# UNITED STATES PATENT AND TRADEMARK OFFICE

10/572,863

Antonio Silvio Sampaio Doria

| <b>Office Action Summary</b> | <b>Application No.</b><br>10/572,863 | <b>Applicant(s)</b><br>DORIA, ANTONIO SILVIO<br>SAMPAIO |  |

**Annotated Partial Fig. 1**

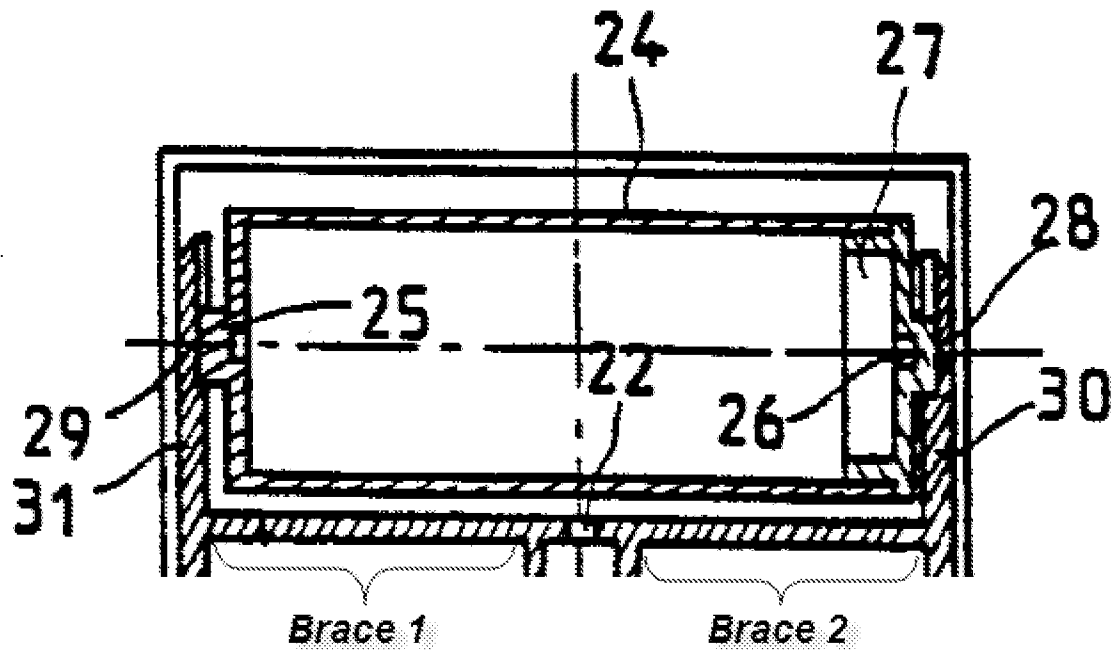
14. In re Claim 1, Lucas discloses a cylindrical applicator for dispensing cosmetic compositions in the form of liquid, cream, gel, and others, onto the human skin, adaptable to various kinds and shapes of packages (Column 1, Lines 60-61), comprising: a cylinder 24 (Fig. 1; Column 2, Lines 36-37), an element bounded by an oblong round wall, such as a tube, and two circular, flat, equal and parallel ends, ("cylinder"; Fig. 1; Column 2, Lines 36-37); and a seat 16 ("distributor"; Fig.'s 1-2;

Column 2, Lines 10-12), which comprises: two semicircular guides ("Guides"; See Annotated Partial Fig. 2 below), directed toward the inside, two support circles 30/31 ("flanges"; Fig.'s 1-2; Column 2, Line 43) at its ends formed by disks of two circumferences, being the upper disk smaller than the lower one ("Upper Disk", and "Lower Disk"; See Annotated Partial Fig. 2 below), with a smaller radius ("R1" and "R2"; See Annotated Partial Fig. 2 below), two inferior braces ("Braces 1/2"; See Annotated Partial Fig. 1 below), which define the length of the distribution opening 22 (Fig.'s 1-2; Column 2, Lines 21-22), being said cylinder encased in said seat by being pressed into it ("engaged via a resilient deformation"; Column 2, Lines 42-43; it being understood that such deformation is achieved by pressing the cylinder with pins, into the depression to cause such resilient deformation), where said cylinder is supported mainly by the semicircular guides (Fig.'s 1-2) and is free to roll.
